Work Order ID 125840

DART SERVICE INSTRUCTION
TO AMEND INSTALLATION INSTRUCTIONS IIN-D350-689 REV. B
AND INSTRUCTIONS FOR CONTINUED AIRWORTHINESS ICA-D350-689 REV. 1
REF. TCCA STC: SH02-33
REF. FAA STC: SR01620NY
REF. EASA STC: EASA.IM.R.S.01453
REF. TCA STC: 2005S03-09

B	CHANGES TO -013 KIT INSTALLATION. REF: CIR12-12.	MB	12.11.09
A	NEW ISSUE	MB	11.12.22
REV.	DESCRIPTION	BY	DATE
DESIGN		DART AEROSPACE LTD HAWKESBURY, ONTARIO, CANADA	
DRAWN			
CHECKED		DRAWING NO.	REV. B
MFG. APPR.	N/A	DSI 9588	SHEET 1 OF 6
APPROVED		TITLE	SCALE
DE APPR.		INSTALLATION CHANGE	NTS
DATE	12.11.09	COPYRIGHT © 2011 BY DART AEROSPACE LTD THIS DOCUMENT IS PRIVATE AND CONFIDENTIAL AND IS SUPPLIED ON THE EXPRESS CONDITION THAT IT IS NOT TO BE USED FOR ANY PURPOSE OR COPIED OR COMMUNICATED TO ANY OTHER PERSON WITHOUT WRITTEN PERMISSION FROM DART AEROSPACE LTD.

FIGURE 1: UPDATES TO CROSS SECTIONS F-F AND M-M
 With reference to Figures 5 and 7 of IIN-D350-689
 (Figures 25-5 and 25-7 of ICA-D350-689)

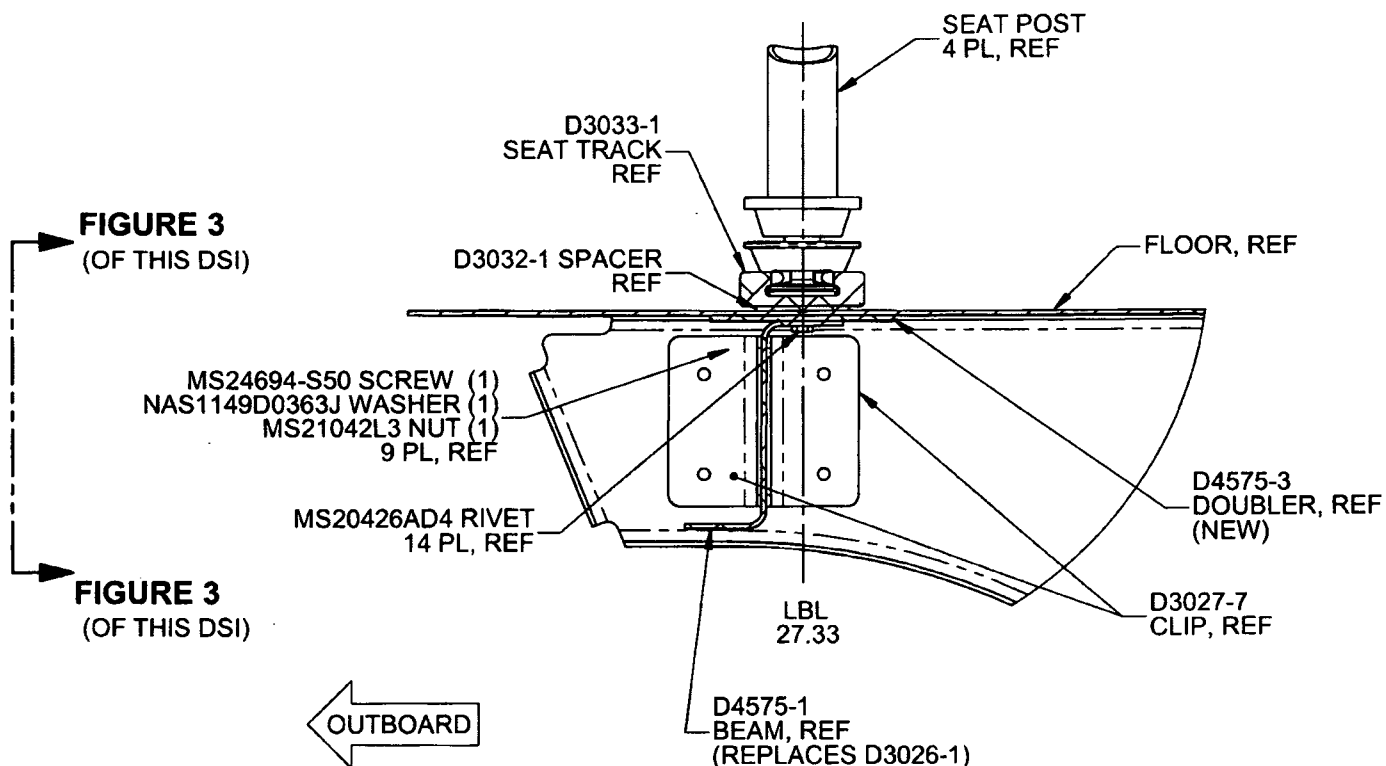
For D350-689-011/-013 at CHG 006/005 and later and D350-689-021/-023 Kits at CHG 005/004 and later, the D3026-1 Channel has been replaced with the D4575-1 Beam and D4575-3 Doubler and the D3234-3 Doubler has been removed. Consequently, the installation instructions for D350-689-011/-013 at CHG 006/005 and D350-689-021/-023 at CHG 005/004 are updated per Section 2.0 of this Service Instruction. The parts list update is shown in Section 4.0 of this Service Instruction. There is a negligible change to the weight and balance.

If there is an existing stringer at LBL 27.33, it will need to be removed from that location. Locate D4575-1 Beam, D4575-3 Doubler, and D3032-1 Spacer as shown in Figure 1 of this Service Instruction. Transfer drill existing holes from the aircraft floor to the D4575-1 Beam, D4575-3 Doubler, and D3032-1 Spacer. Ensure 1.0" to 1.5" rivet pitch and add additional holes if required. If there is no existing stringer, locate D4575-1 Beam, D4575-3 Doubler, and D3032-1 Spacer as shown in Figure 1 of this Service Instruction and drill Ø0.128" holes on a 1.0" to 1.5" pitch.

Counter sink holes in the D3032-1 Spacer for MS20426AD4 rivets. Install D4575-1 Beam, D4575-3 Doubler, and D3032-1 Spacer to floor using MS20426AD4 rivets.

FIGURE 2: UPDATES TO FIGURE 21 (IIN-D350-689) AND 25-21 (ICA-D350-689)
 With reference to Figures 19 and 20 of IIN-D350-689
 (Figures 25-19 and 25-20 of ICA-D350-689)

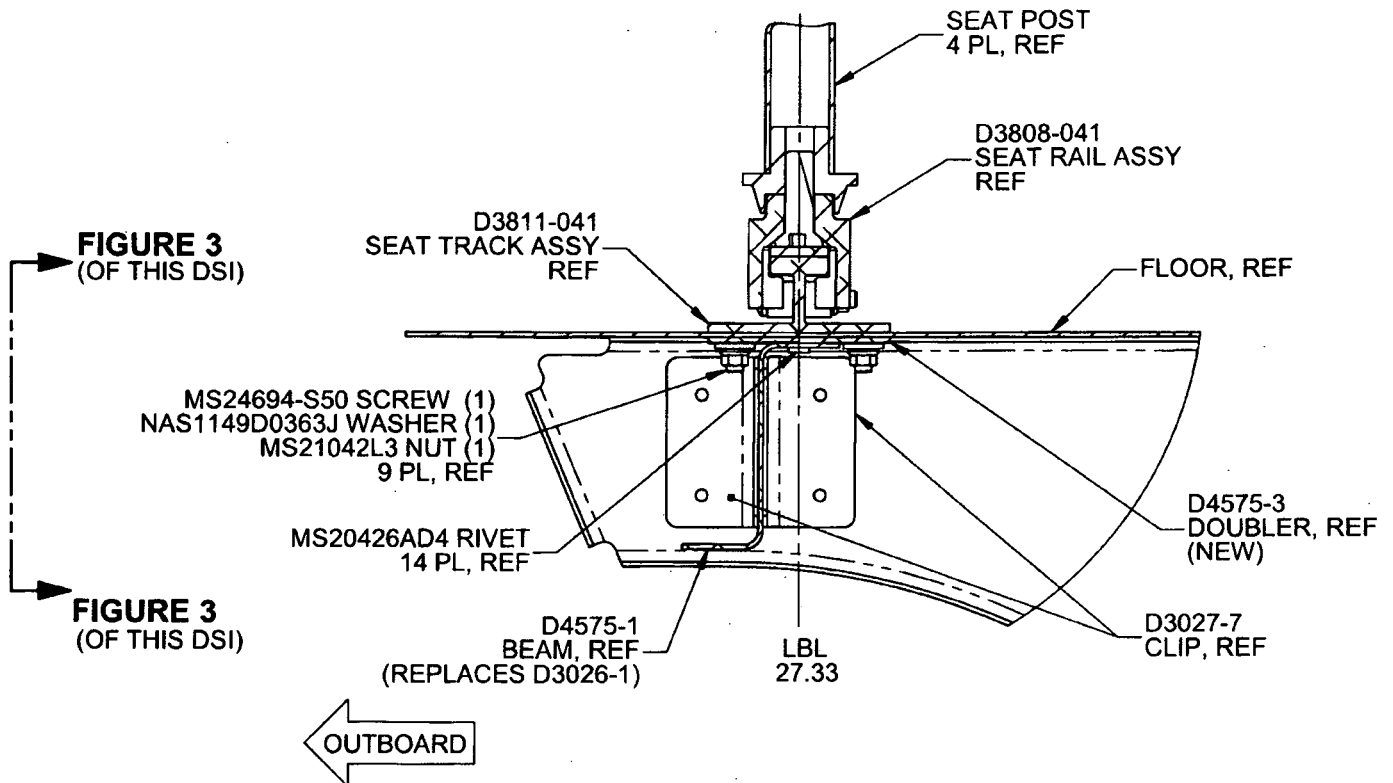
If there is an existing stringer at LBL 27.33, it will need to be removed from that location. Locate D4575-1 Beam and D4575-3 Doubler as shown in Figure 2 of this Service Instruction. Transfer drill existing holes from the aircraft floor to the D4575-1 Beam and D4575-3 Doubler. Ensure 1.0" to 1.5" rivet pitch and add additional holes if required. If there is no existing stringer, locate D4575-1 Beam and D4575-3 Doubler as shown in Figure 1 of this Service Instruction and drill Ø0.128" holes on a 1.0" to 1.5" pitch.

Attach D4575-1 Beam and D4575-3 Doubler to floor using qty (14) MS20426AD4 rivets.

FIGURE 3: RELIEFS ON D4575-1/-3
(ONLY D4575-1/-3 SHOWN FOR CLARITY)
VIEW LOOKING INBOARD

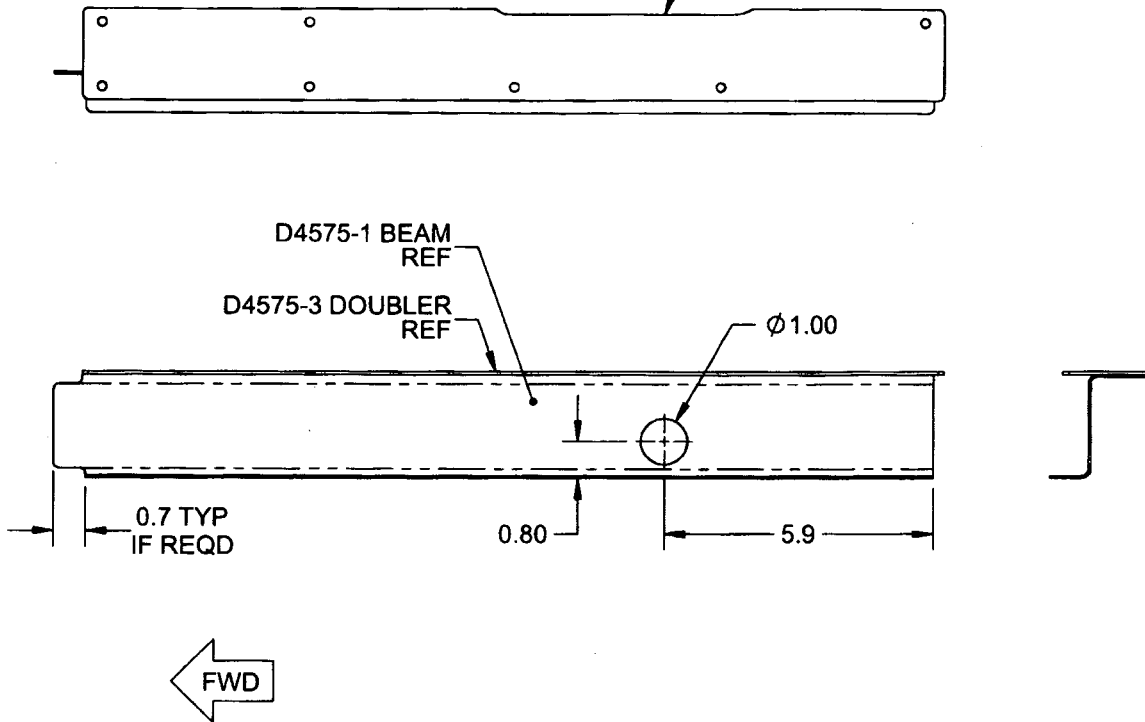
Note: Drill a Ø1.00" (Ø25.4 mm) hole in the D4575-1 Beam to clear extension tube of collective and cutout as required for clearance of collective opening and fwd bulkhead as shown in Figure 3 of this Service Instruction.

Note: Drill a Ø1.00" (Ø25.4 mm) hole in the D4575-1 Beam to clear extension tube of collective and cutout as required for clearance of collective opening and fwd bulkhead as shown in Figure 3 of this Service Instruction.

TRANSFER EXISTING CUTOUT
FROM AIRCRAFT FLOOR A/R TO
D4575-1/-3 FOR COLLECTIVE OPENING
